Environmental Assessment

Adams Shore/Houghs Neck Seawall Repairs and Improvements Project

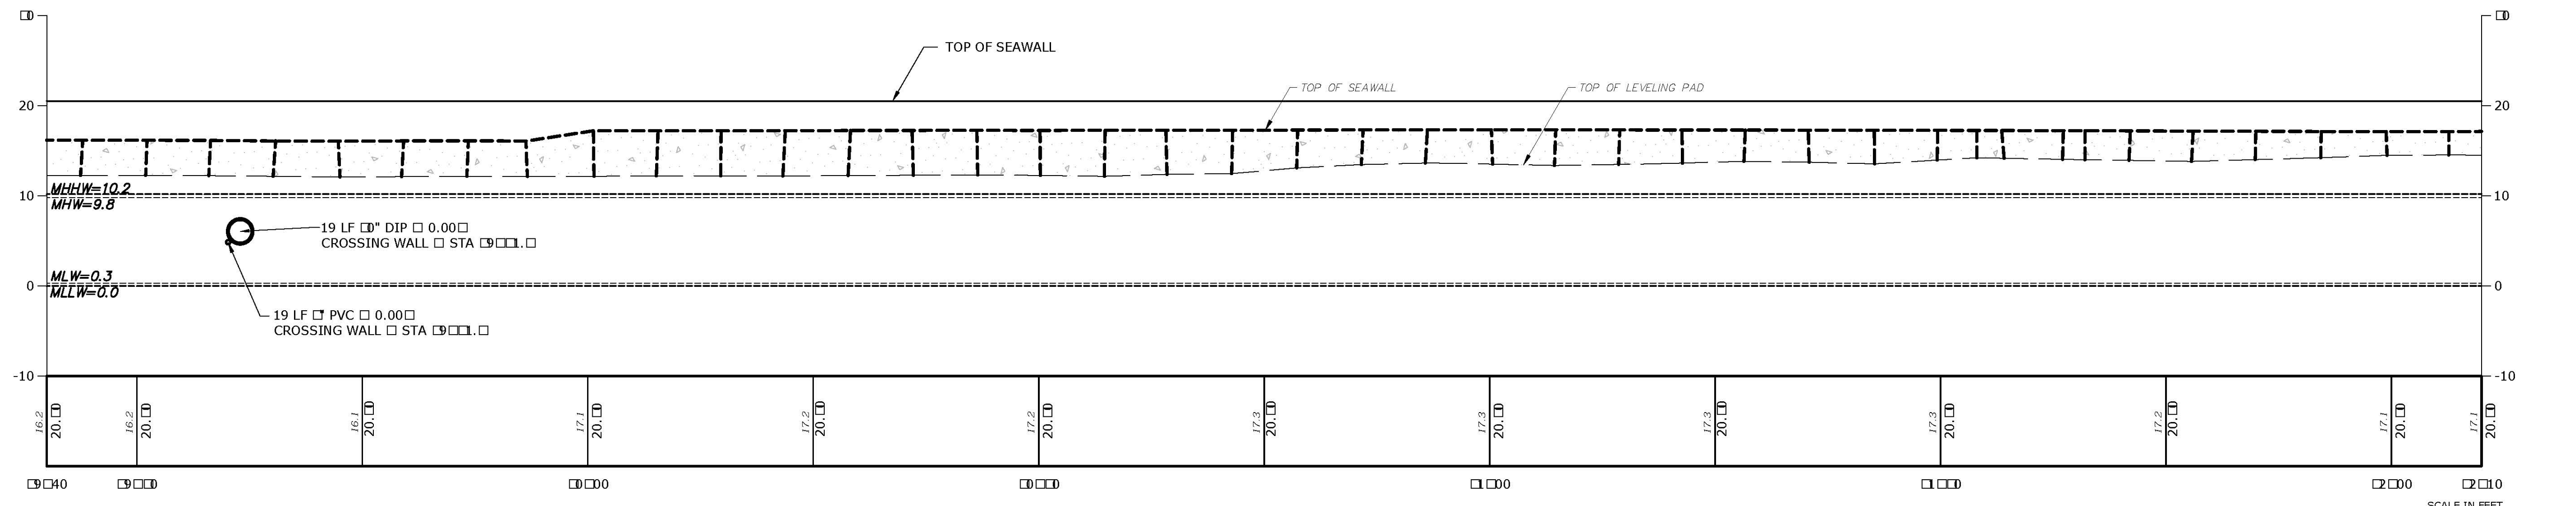
MARK	DATE	DESCRIPTION
1	7/27/2019	ADDENDUM 1
